# MONTGOMERY COUNTY PLANNING DEPARTMENT

May 14, 2010

**SUBJECT:** Mandatory Referral No. 09720-M-1: Montgomery College Bioscience Building  
Mandatory Referral No. 10712-M-1: Childcare Center  
Germantown Campus - I-3 Zone

### STAFF RECOMMENDATION: *Approval To Transmit Comments*

# Observation Drive Extended, Council Approved

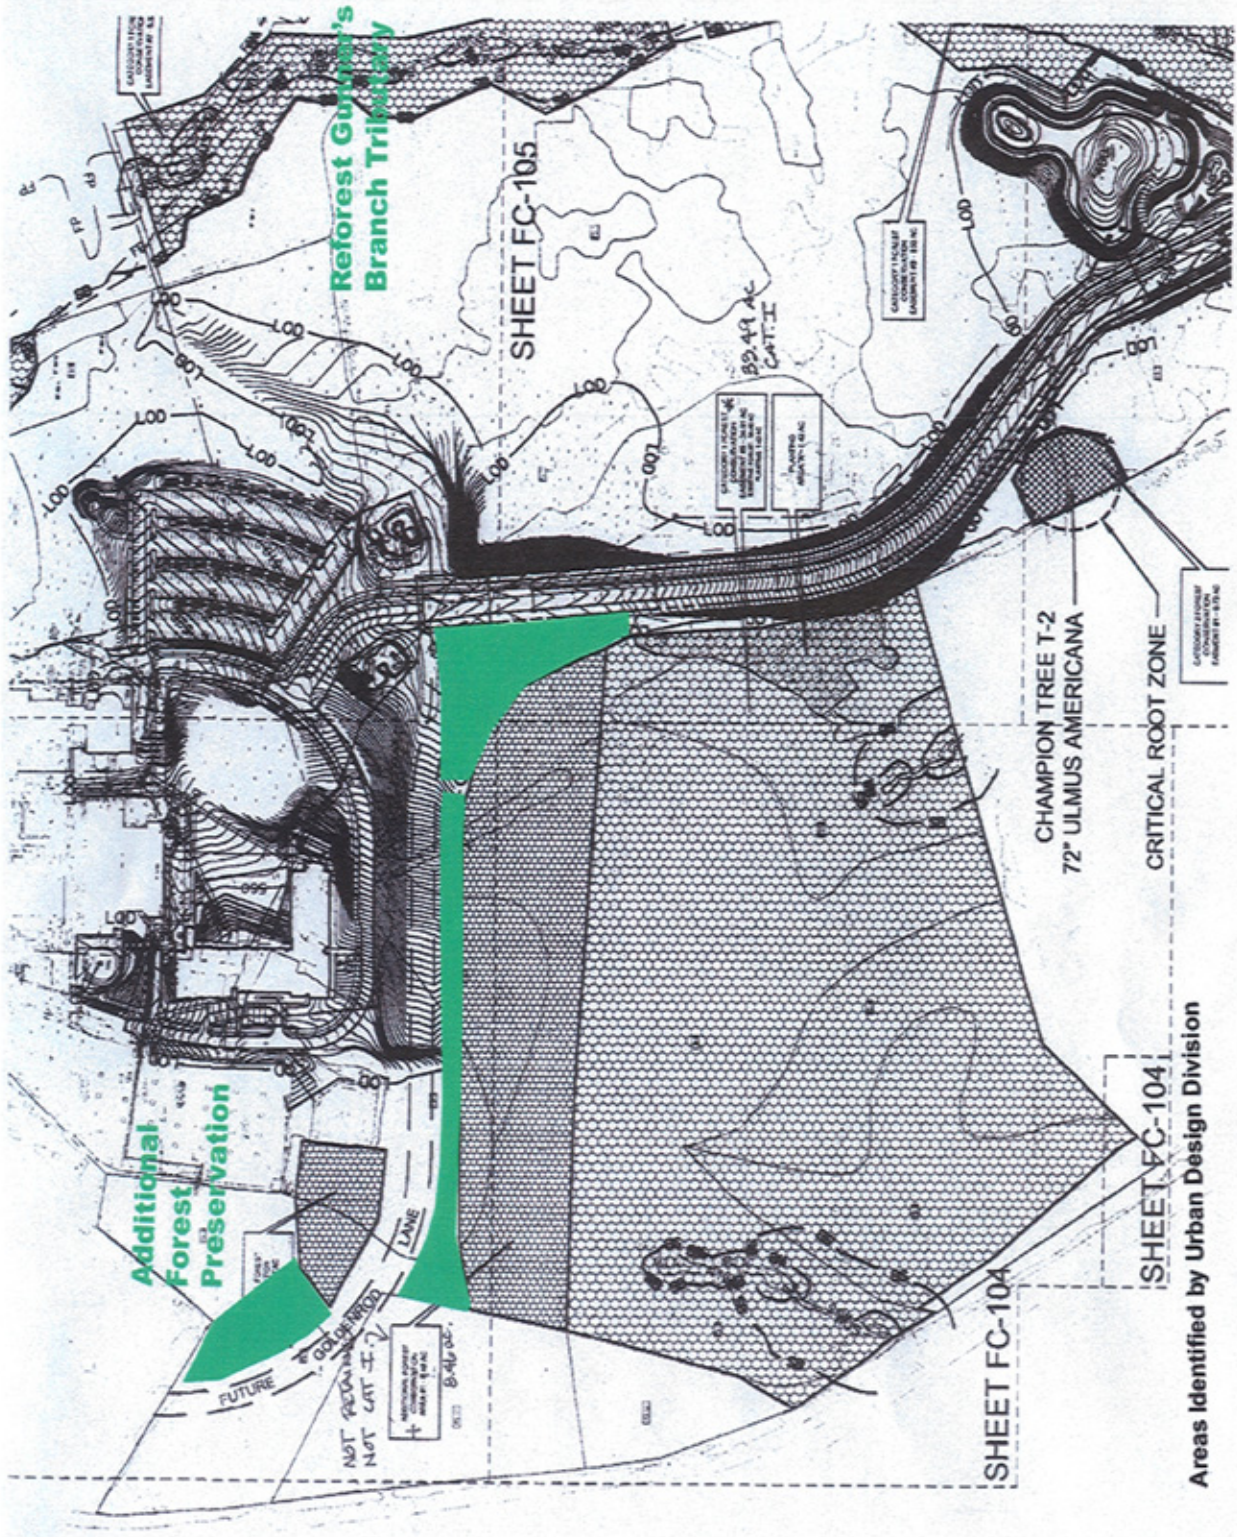
**Roadway Alignments** - The proposed and future alignment of Observation Drive Extended and Cider Press Place are generally in conformance with the Sector Plan. The College intends to build the southern portion of Observation Drive Extended as an arterial roadway connecting the College to Middlebrook Road with future segments of Observation Drive and Cider Press Place built by developers of the Technology Park. In the future, a traffic circle at the intersection of Observation Drive and Cider Press Place is proposed to be built by others. The minor differences in alignment between the College's proposal and the Council's approved alignment including the future traffic circle affect the amount of preserved forest (see Attachments C and D). The College proposes a western shift in the southern road alignment to Middlebrook Road in order to increase the development area for the Technology Park and potential hospital.

The proposed arterial road section will need a sidewalk on both sides of the street to conform to the Road Code and provide pedestrian access.

- **Pedestrian Circulation:** The new roadways do not provide pedestrian access on both sides of the street. The new arterial roadway, Observation Drive Extended, provides a 10 foot shared-use pathway on the east side only. This does not conform to the Road Code section 2004.08 that requires sidewalks on both sides of the street. The Sector Plan envisions development on both sides of this roadway in the southern end of the site and pedestrian access on both sides will be safe for pedestrians.

The future extension of Observation Drive west to connect to Goldenrod Lane is shown with a future traffic circle intersection. Traffic circles are not as pedestrian friendly as a four-way intersection with stop signs. The College should consider deleting the traffic circle to be built by others.

# Montgomery College 2006-2016 Land Use Plan

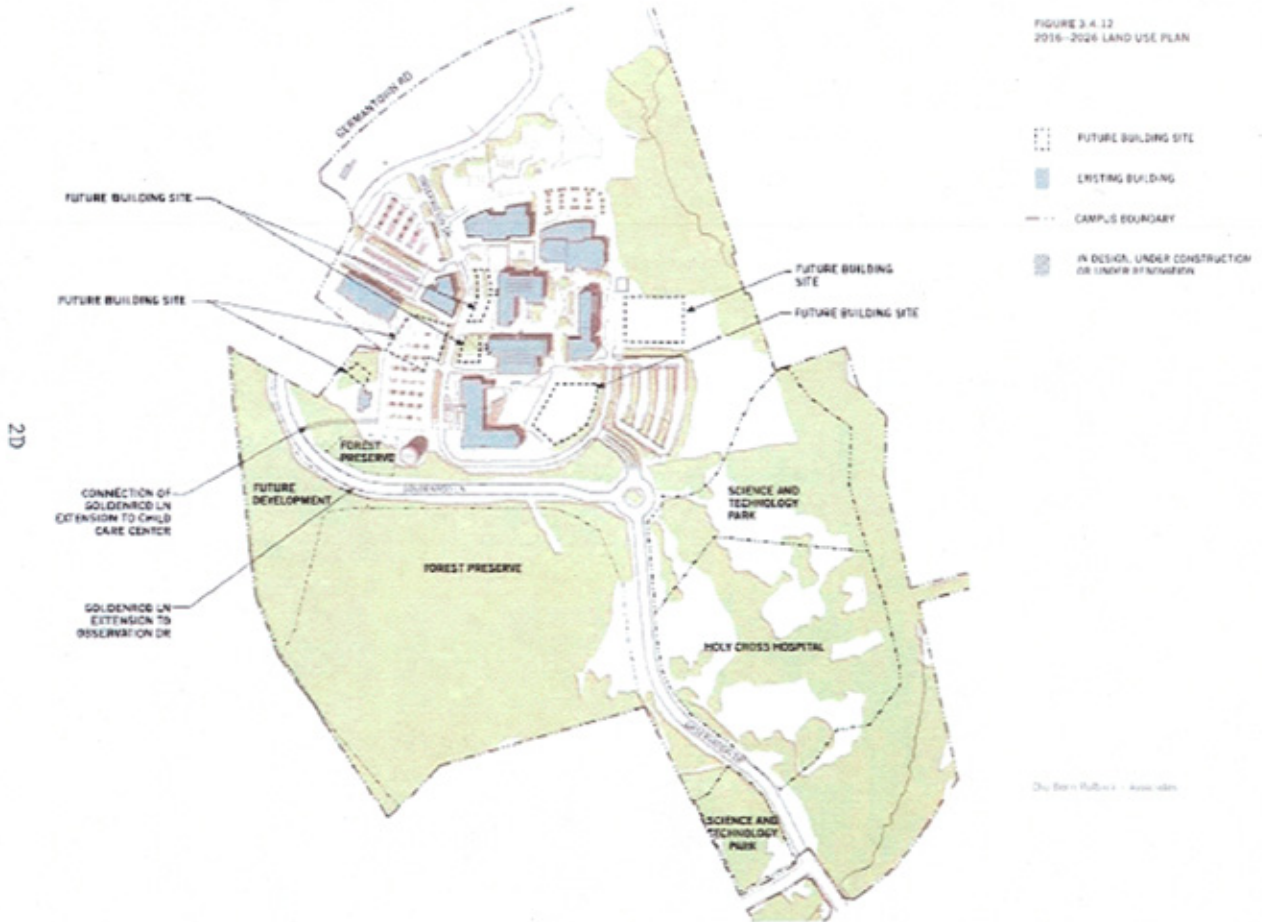
**Revisions to the College 2008 Master Plan** - The College's recently updated master plan, dated June 17, 2008, does not illustrate the 2007 Sector Plan's roadway network that includes a connection to Cider Press Place. A revised college master plan should incorporate all Sector Plan roadways and compact development and future structured parking (see Montgomery College Facilities Master Plan, Attachment F).

5. Update the Master Plan to reflect the proposed improvements.

# Bioscience Building Landscape Plan

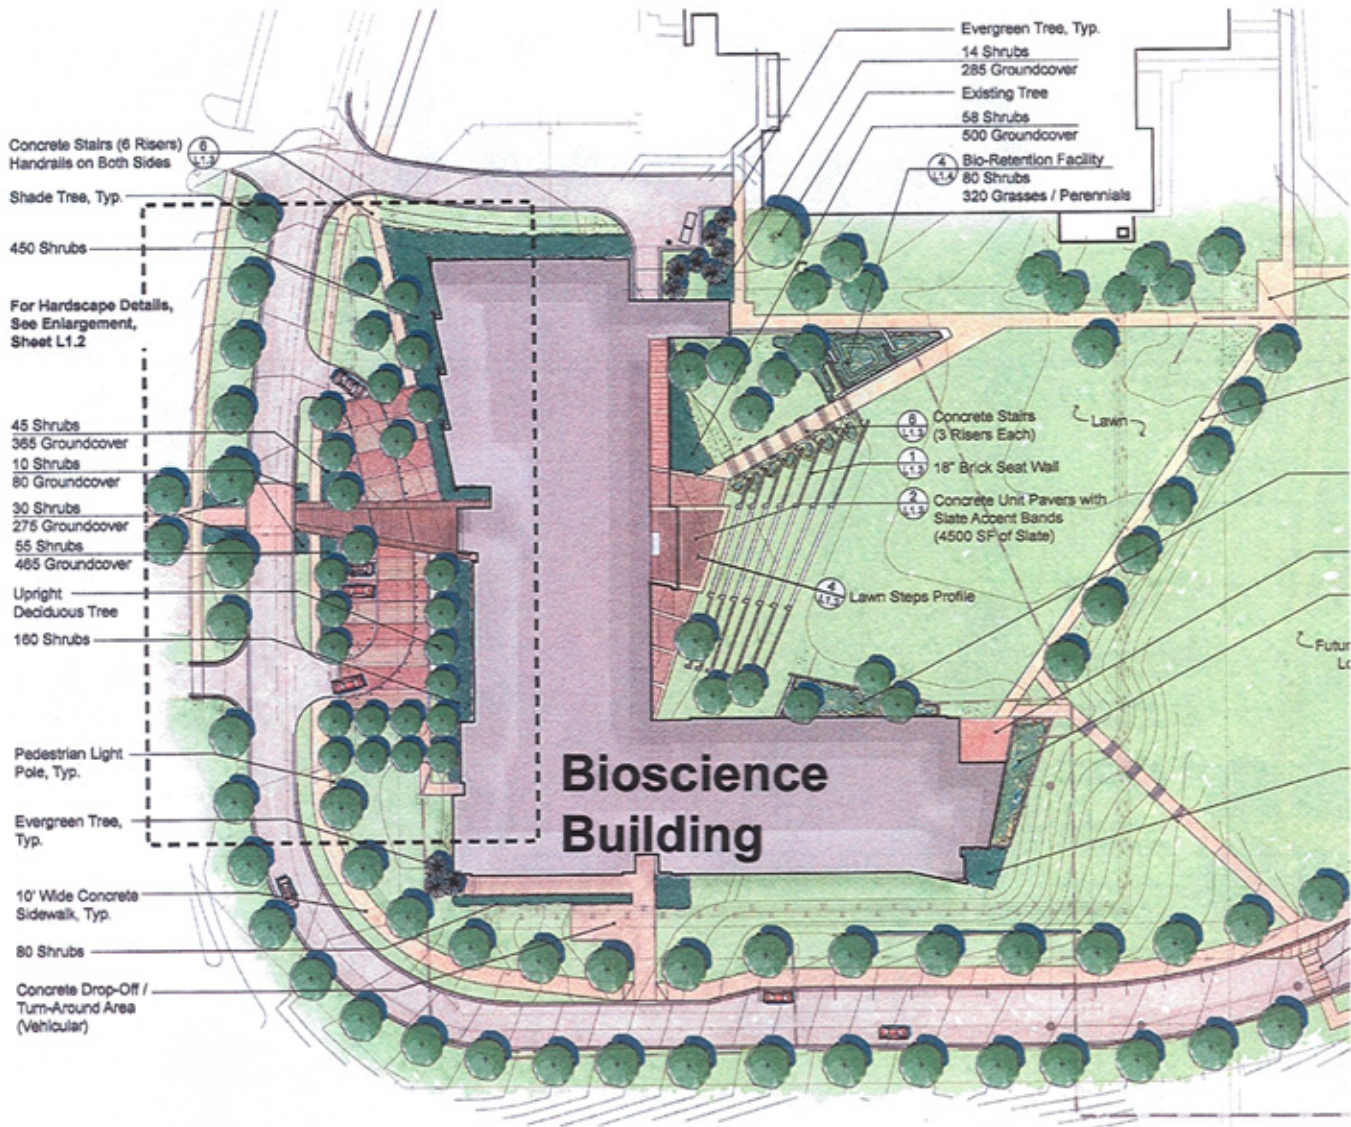
- **Landscape –** The Bioscience Building's landscape plan shows an attractive landscape treatment for the building and adjacent open spaces primarily relying upon deciduous shade trees to frame the building. The plans also show sufficient street tree plantings along the campus loop roadway, within the proposed parking lot, and adjacent to the entrance of the new building (see Bioscience Building Landscape Plan, Attachment G).

The plan does not propose to plant street trees along the new arterial roadway connecting to Middlebrook Road. The new roadway should be planted with street trees to establish a tree canopy, separate pedestrians from moving traffic, and create an attractive street. The College intends for street trees in this section of the site to be the responsibility of future private development. Street trees should be an integral part of the roadway improvement and not a future improvement.

- e. expand reforestation of the Gunner's Branch Stream Valley.
2. Locate all street trees between the curb and the sidewalk. Provide street trees for the entire length of the new arterial roadway. Provide a minimum five-foot wide sidewalk on both sides of all roads.
